Z-22-2017-GIS

| APPLICANT: Venture Homes, Inc. | PETITION N | O.: <u>Z-22</u> |
| ZONING COMMENTS: Staff Men | mber Responsible: Jason A. Campl | bell |

The applicant is requesting the Fee-Simple Townhouse (FST) zoning district for the purpose of developing a 67-unit townhouse subdivision. The units will range in size from 1,800 square feet to 2,400 square feet and the architecture will be traditional/Craftsman. The townhomes will have a mixture of front and rear loading garages as shown on the attached renderings.

Site Plan

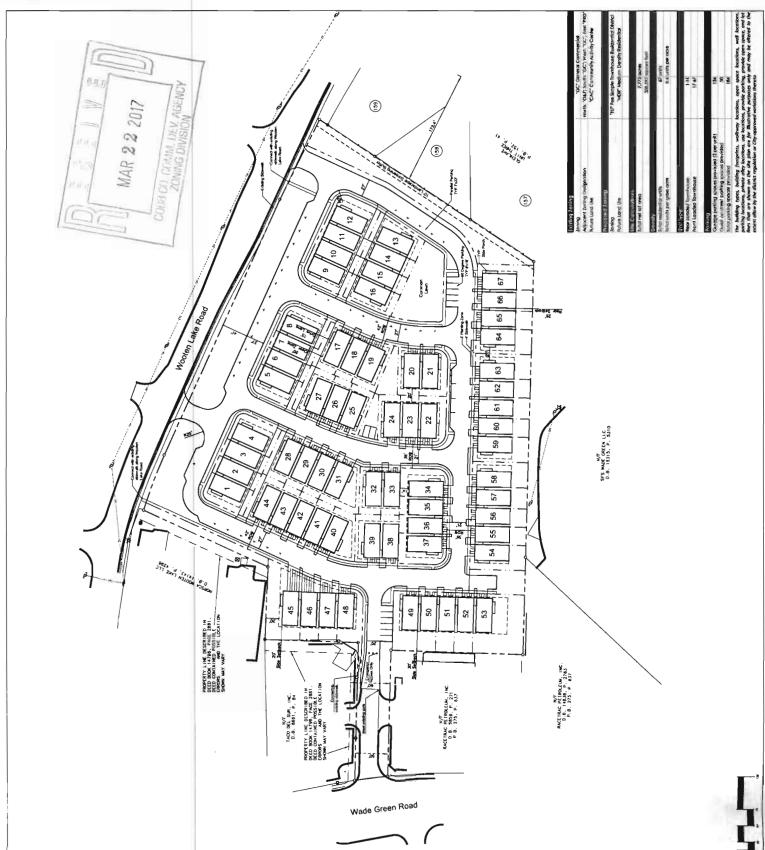
- 1. Waiving the rear setback for exterior lots from the required 35 feet to 25 feet along the southern property line; and
- 2. Waiving the side setback for exterior lots from the required 40 feet to 20 feet on the north side of the units on the western property line and to 30 feet on the units along the southwest property line.

- 2. Although not indicated on the preliminary site plan, a stormwater management facility will be required and will likely be located at or near the southeast corner of the site at the current discharge point from the site. This will likely result in the loss of Units 64-67.

- 3. Offsite runoff from the existing commercial developments to the west along Wade Green Road must be conveyed through the site. There are two existing detention ponds located along the western boundary of the site that currently provided stormwater management for the 1415 Wooten Lake Road Medical Building and the Taco Bell located at 4370 Wade Green Road. If left in place these ponds will need to either be deeded to those commercial entities or inter-parcel maintenance agreements provided. If the ponds are removed, stormwater management for those sites must be accounted for and provided in the onsite master detention facility.

- B. It is Staff's opinion that the applicant's rezoning proposal will have an adverse effect on the usability of adjacent or nearby property. The property is currently access through a driveway extending from Wade Green Road. The proposed site plan will add two driveways on Wooten Lake Road in addition to the existing drive from Wade Green Road.

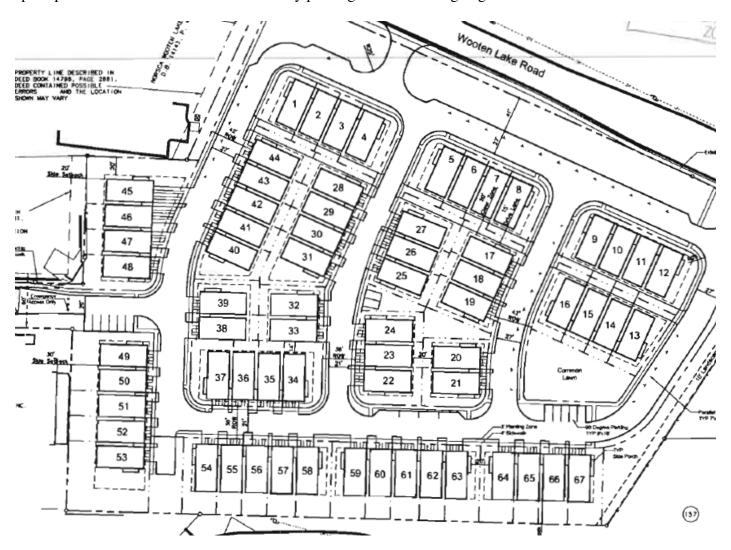
Modifications will be required to incorporate the Cobb County Fire Marshal's Office comments.

GUEST PARKING: The Fire Department recommends dedicated guest parking be provided at a ratio of 1 space per unit as each unit does not have any parking outside of the garage.
